Date: 03-17-25

Project Number: 56-3016-25

Project Name: HPWO - New Carlisle Phase 1 Selective Demolition - Community Health Center

Intent:

DRAWN BY:	JLV
DATE:	11-24
PLOT SCALE:	1:1
JOB NO.	56-3016-24
SHEET	D102

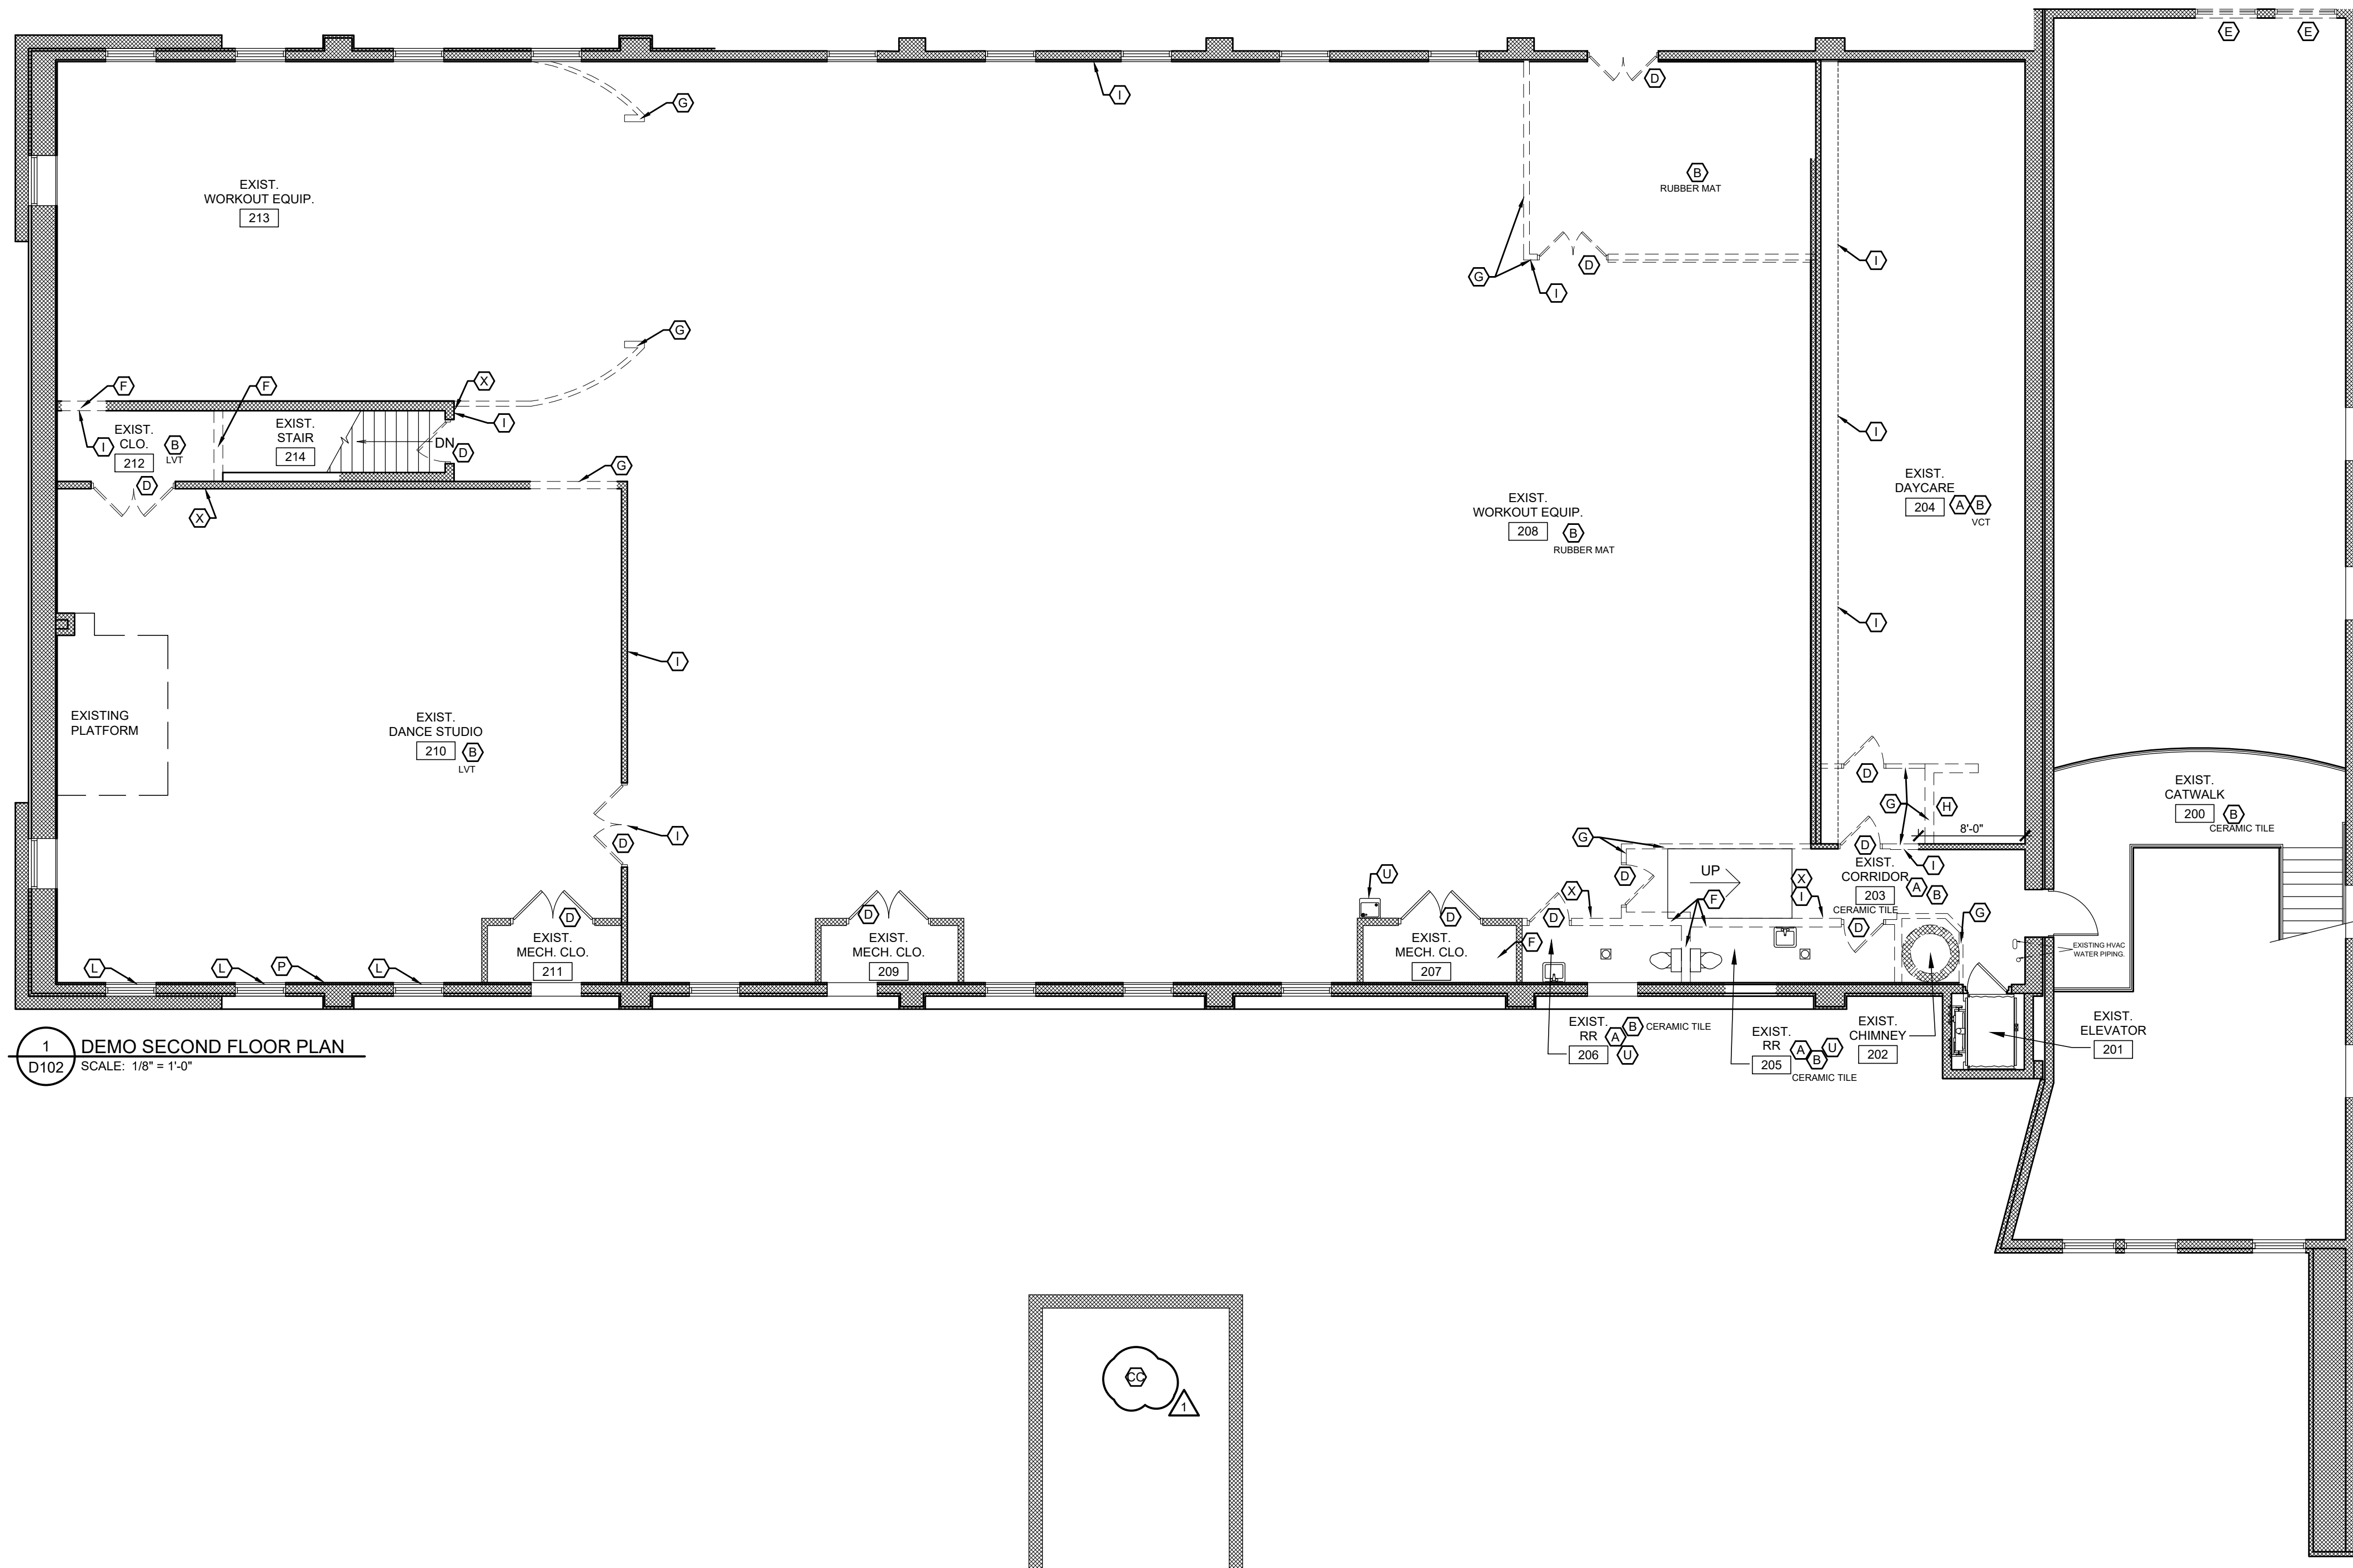
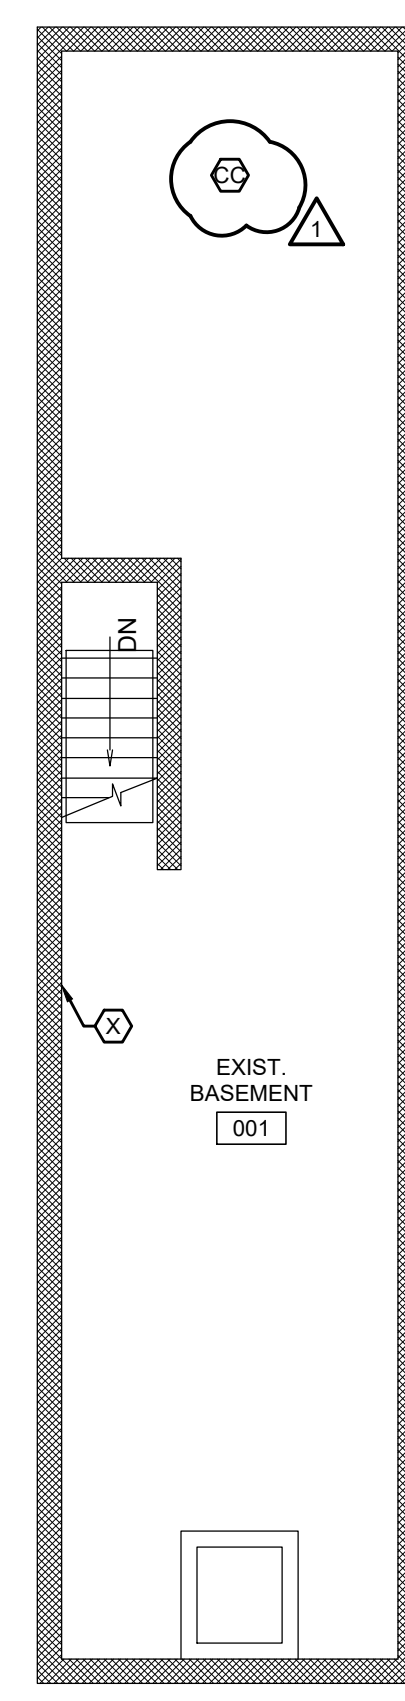
Item	Additional Document	Cons. Doc. Reference	Description
General:			
1	Pre-bid Mtg. Minutes		See attached
Architectural:			
2		D101	Keynotes CC & DD added, existing shelving to be salvaged. Owner to retain
3		D102	Keynotes CC & DD added, existing shelving to be salvaged. Owner to retain
Mechanical / Plumbing:			
4		DP103	Keynote 15 edited, existing chimney to remain
5		DM103	Keynote 15 edited, existing chimney to remain
End of Addendum 01

- (BB) REMOVE WOOD WALL COVERING
- (CC) EXISTING SHELVING TO REMAIN IN PLACE, OWNER TO RETAIN
- (DD) REMOVE & SALVAGE EXIST. SHELVING, OWNER TO RETAIN

DRAWN BY: SAB
DATE: 11-24
PLOT SCALE: 1:1
JOB NO. 56-3016-24
SHEET DP103

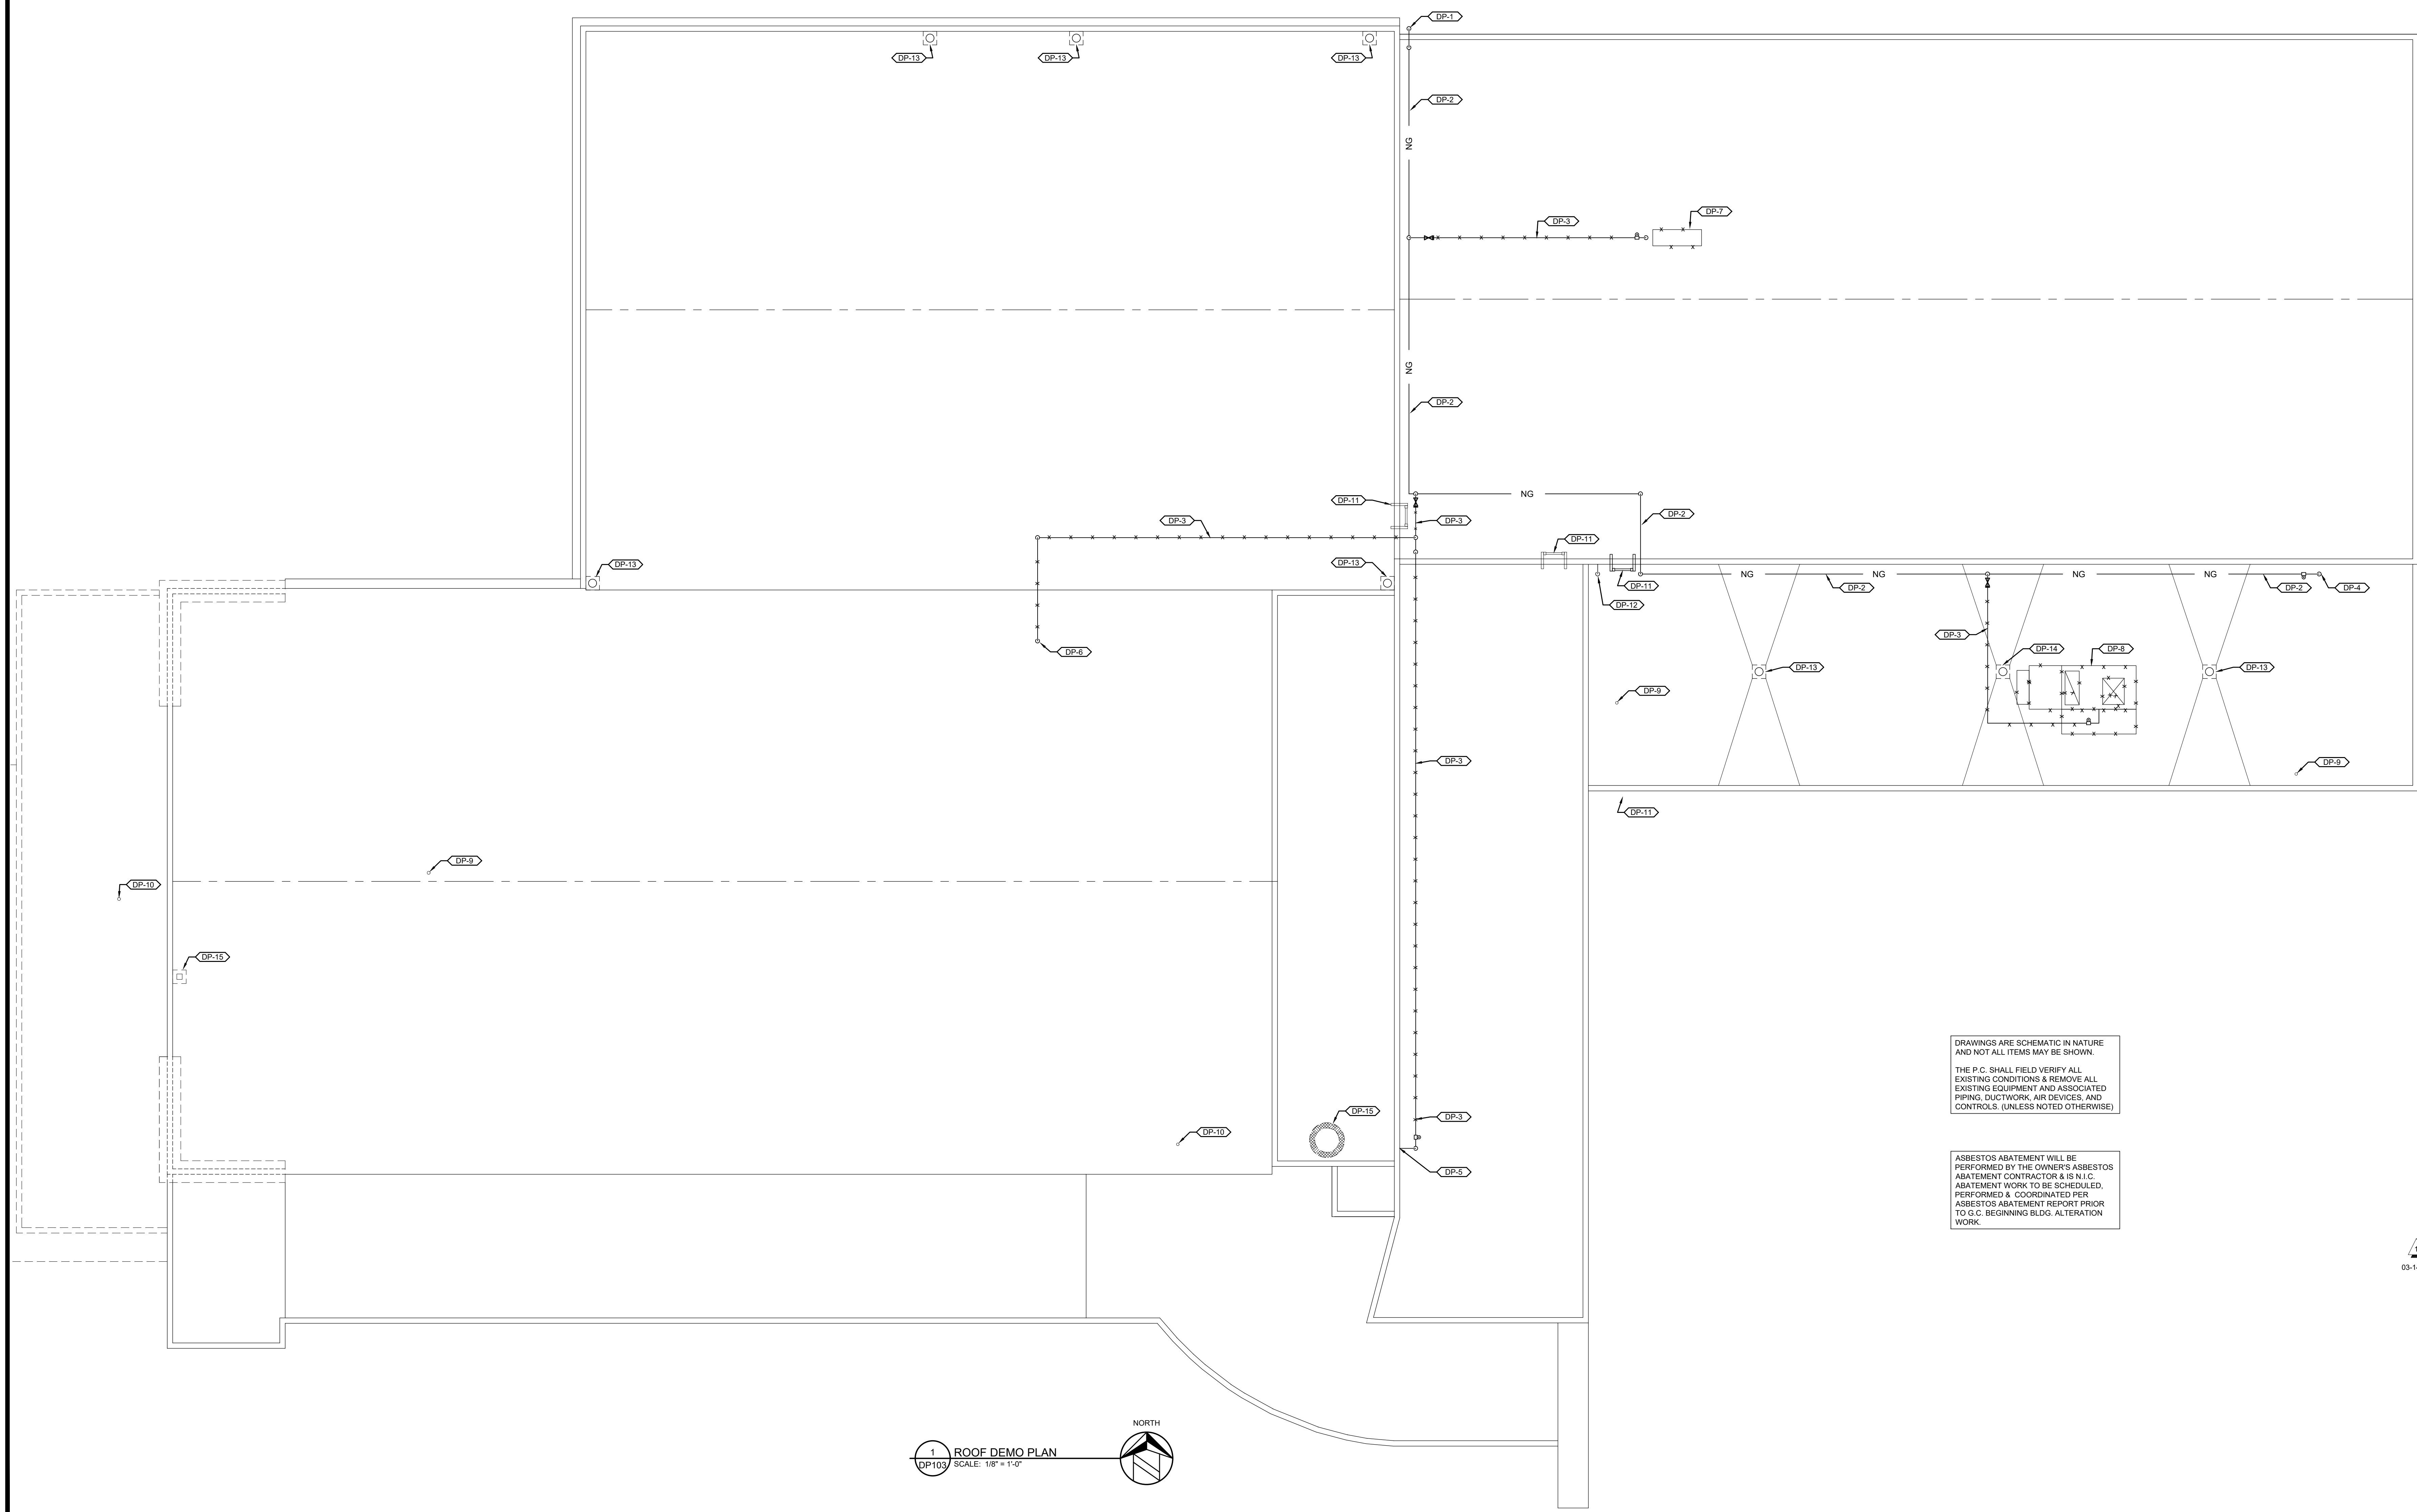
- EXISTING OVERFLOW DRAIN TO REMAIN.
- EXISTING CHIMNEY TO REMAIN.
